## **Intelsat response to Ofcom consultation document on the application for a variation to Freedom4's '3.6 GHz licence'**

## ANNEX 1

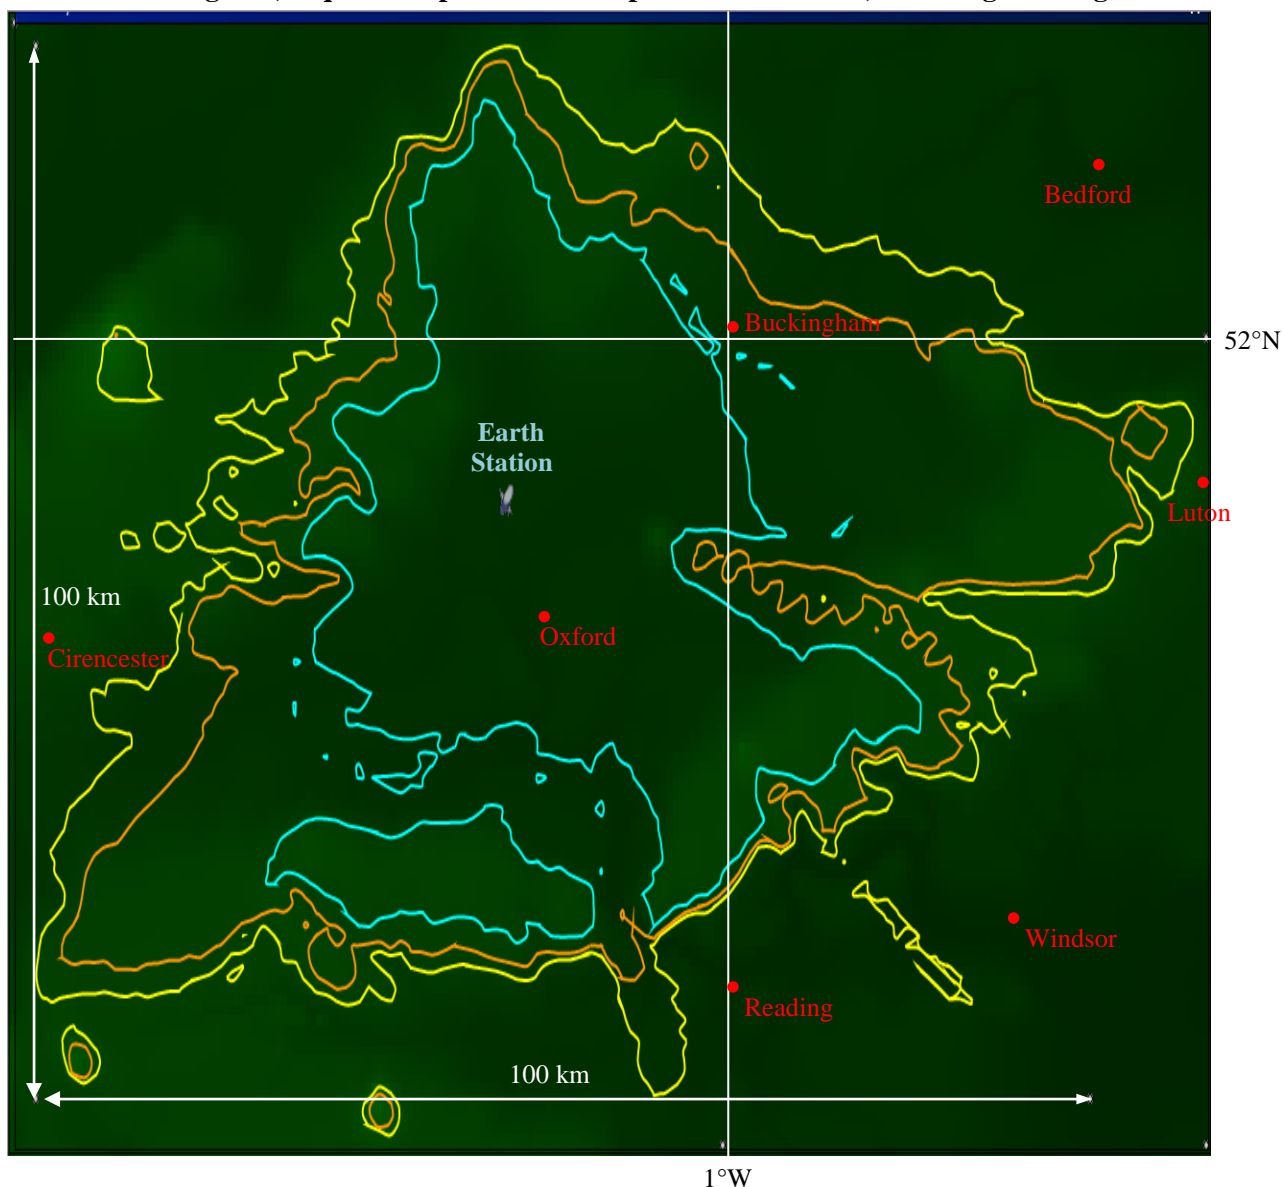
1. We strongly endorse the retention of the requirement for Freedom4's central stations to coordinate, but note that the proposed increase in central station EIRP density would increase the sizes of the coordination areas. As an example, in Annex I contours are plotted around a hypothetical FSS earth station in central England for the existing and proposed central station EIRP densities. Within each of these contours the long-term protection criterion used in the ITU-R studies for WRC-07 agenda item 1.4 would be exceeded at the earth station, unless some form of interference-mitigation technique was implemented (e.g. use by Freedom4 central stations of sector antennas with 'nulls' in the direction of the earth station). In this example the average coordination distance would increase from 40 to 45 km.

4. Although Freedom4’s application does not request an increase in the maximum EIRP density of the low-power terminals, it should be noted that the existing limit of 25 dBm/MHz is **17.5 dB higher** than the figure used in the ITU-R preparatory studies for WRC-07 Item 1.4. Nevertheless, the map in Annex I includes a contour within which a low-power terminal would exceed the long-term protection criterion at the example earth station. The corresponding average coordination distance would be of the order of 26 km, i.e. 19 km less than the distance for a central station. The fact that this difference is much greater than the radius of a typical WiMAX cell (e.g. 5km) suggests that, provided the central stations are successfully coordinated, interference from the low-power terminals is unlikely to be significant. However, Intelsat cannot support the removal of the requirement for low power terminals to coordinate unless and until we are satisfied that the coordination of the central stations will guarantee protection for satellite earth stations from harmful interference. If the arrangements for coordination with the central station are inadequately defined the removal of the requirement to coordinate the low power terminals will compound the interference suffered by the satellite earth station and the quality of service available to its users.

5. From the frequency-sharing viewpoint the most significant problem with Freedom4’s application is the request for the low-power terminals to be mobile. In order to provide service throughout a given area this would require the central stations to be able to transmit in all horizontal directions. Although in principle each central station could protect satellite earth stations within that area by using antennas with nulls in the appropriate directions, the terrestrial system would then be unable to serve mobiles while they were in the vicinities of the satellite earth stations. In other words there would be substantial ‘holes’ in the Freedom4 coverage of that area. Of course this problem would not arise in an area in which there were no satellite earth stations, but it would severely limit the aim to provide mobile service throughout the UK. From Annex 1 it can be deduced that a typical size of area within

which a satellite earth station would need long-term protection from Freedom4 central stations would be of the order of 6500 Km<sup>2</sup>.

#### ANNEX 2

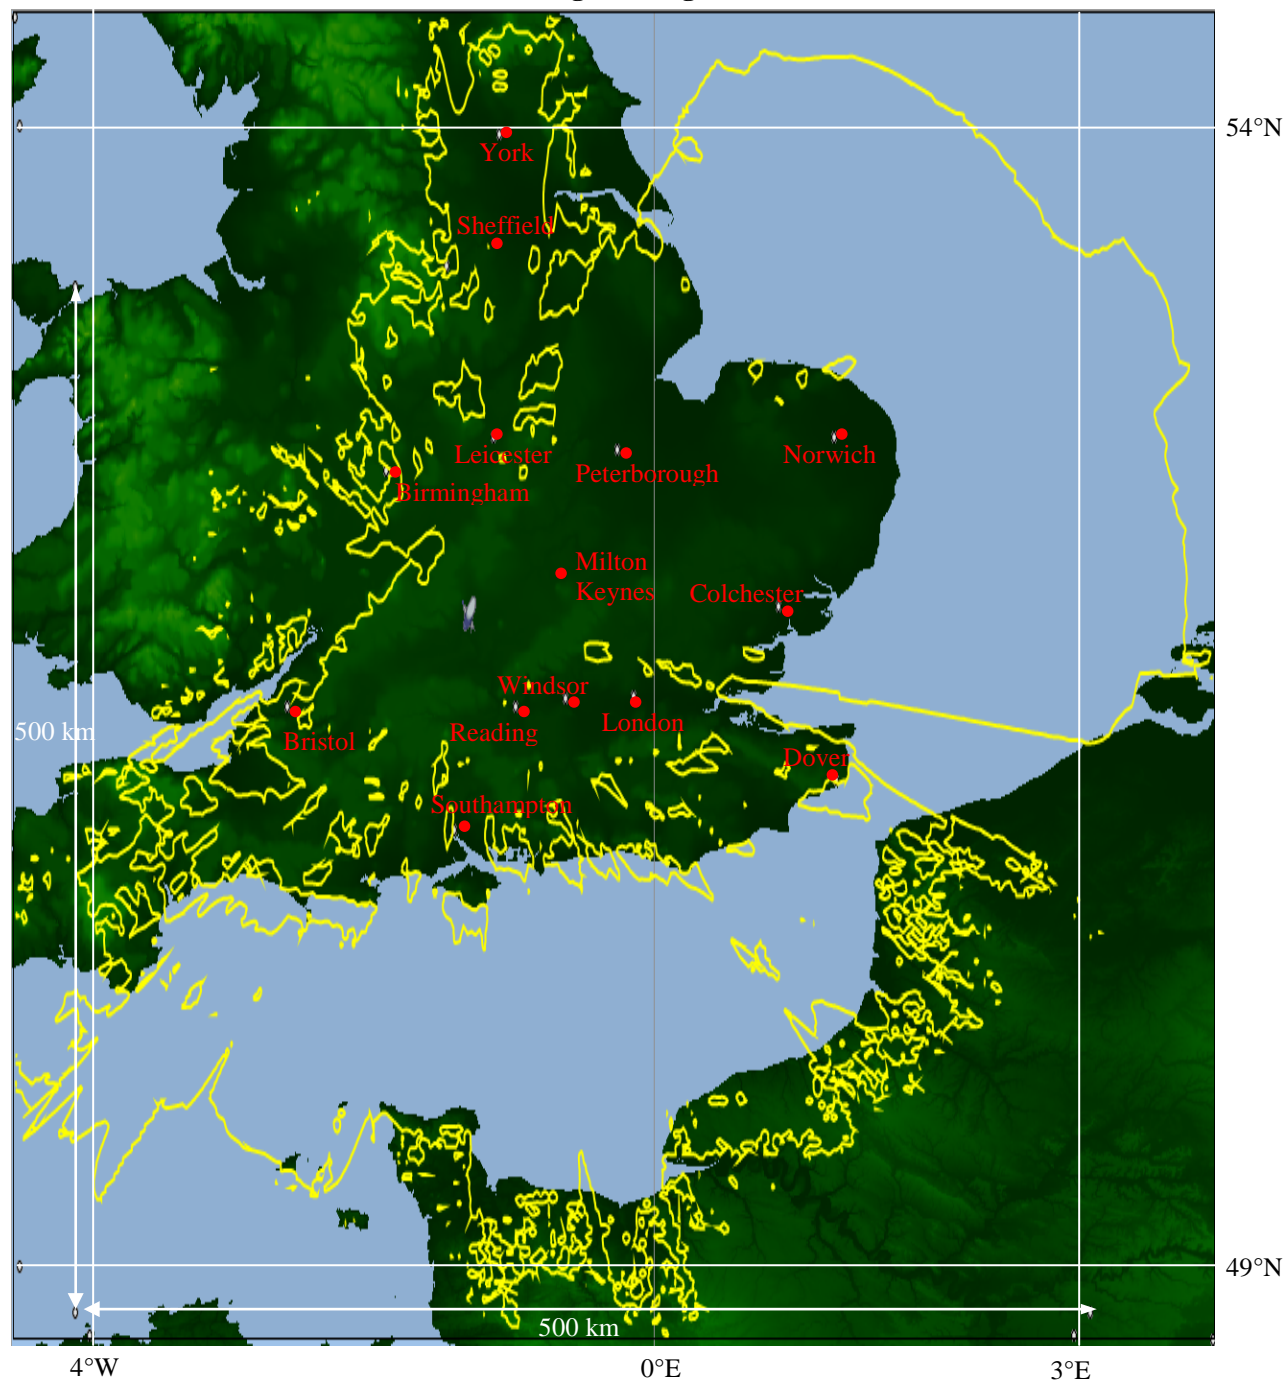
Note: substantially longer distances correspond to the short-term protection criterion used in the ITU-R studies for WRC-07 agenda item 1.4. This is as shown in Annex 2 for the same earth station, where the average distance to the contour exceeds 200 km.
